# Report on Review of Bay Delta Conservation Program Modeling

Since December 2012, MBK Engineers and Dan Steiner (collectively “Reviewers”) have assisted various parties in evaluating the operations modeling that was performed for the Bay Delta Conservation Plan (BDCP). To assist in understanding BDCP and the potential implications, stakeholders<sup>1</sup> requested that the Reviewers review the CalSim II modeling studies performed as part of the BDCP (hereafter “BDCP Studies” or “BDCP Model”).

**Figure 24. Delta Outflow Change (Alt 4-ELT minus NAA-ELT)**

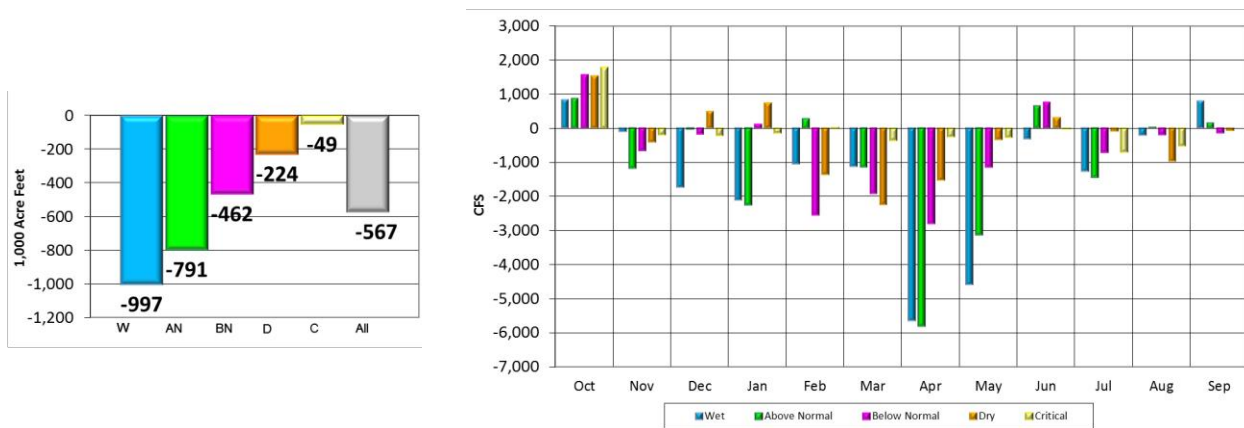
Figure 24 illustrates a comparison of Delta outflow between the NAA-ELT and Alt 4-ELT. Decreases in Delta outflow are the result of the CVP and SWP ability to increase Delta exports in Alt 4-ELT. The apparent increase in Delta outflow in October is partially due to additional export restrictions though Old and Middle River flow requirements. However, the increase in October Delta outflow is also due to an unrealistic operation of the Delta Cross Channel. The additional export restrictions cause the flow standards imposed at Rio Vista to be the controlling point in CVP and SWP operations; the water quality standards are all being met and do not require

flows above the amount needed to satisfy the Rio Vista standard. Meeting the Rio Vista flow standards without closing the Delta Cross Channel gate results in releasing more water from upstream reservoirs than would otherwise be necessary. This occurs because a certain amount of the water released to meet the Rio Vista flow standards would flow into the Central Delta at location of the Delta Cross Channel gate. This water would not make it to Rio Vista and therefore would not be counted towards meeting the Rio Vista flow standards. However, due to the BDCP model's assumed restrictions on exports at this time, this water could not be pumped from the South Delta facilities and thus ends up as "extra" Delta outflow. By closing the Delta Cross Channel gate, the operators would assure that all of the water released to meet the Rio Vista flow standards would be counted towards those standards. The BDCP model's assumptions that the Delta Cross Channel gate would not be closed are not practical or a sensible operation as the operators confirmed they would close the gate during these conditions to avoid the unnecessary loss of water supplies (as was done in October and November 2013). The assumption in the BDCP model to maintain the gate in the open position causes it to overstate the amount of Delta outflow.
